UNITED STATES OF AMERICA
NUCLEAR REGULATORY COMMISSION

In the Matter of)
)
Rochester Gas and Electric Corporation) Docket No 50 244
(R. E. Ginna Nuclear Power Plant,)
Unit No. 1))

APPLICATION FOR AMENDMENT
TO OPERATING LICENSE

Figure 3.1.4-1

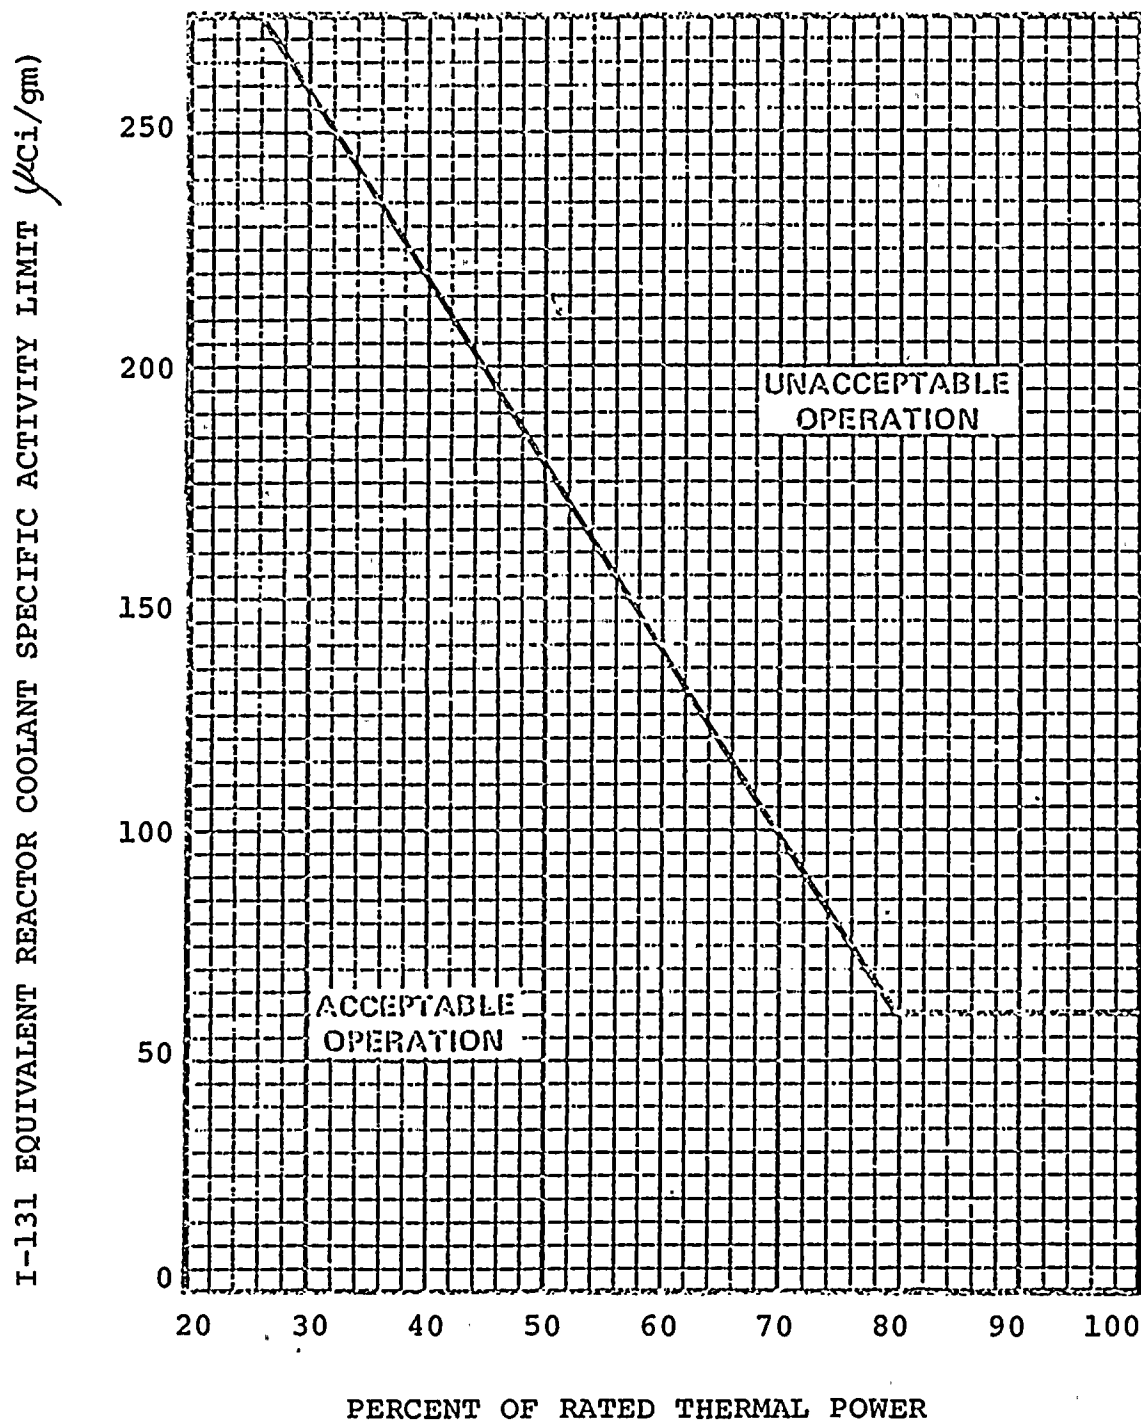
3.1.4.3 a. If the I-131 equivalent activity in the reactor coolant exceeds the limit of 3.1.4.1.b but is less than the allowable limit shown on Figure 3.1.4-1, operation may continue for up to 48 hours provided that the cumulative operating time under these circumstances does not exceed 800 hours in any consecutive 12-month period. If the I-131 equivalent activity in the reactor coolant exceeds the limit of 3.1.4.1.b for more than 500 hours in any consecutive 6-month period,

- b. If the I-131 equivalent activity exceeds the limit of 3.1.4.1.b for more than 48 hours during one continuous time interval or exceeds the limit shown on Figure 3.1.4-1, be subcritical with reactor coolant average temperature less than 500°F within 8 hours.
- c. If the I-131 equivalent activity exceeds the limit of 3.1.4.1.b, then perform sampling and analysis as required by Table 4.1-4, item 4a, until the activity is reduced to less than the limit of 3.1.4.1.b.
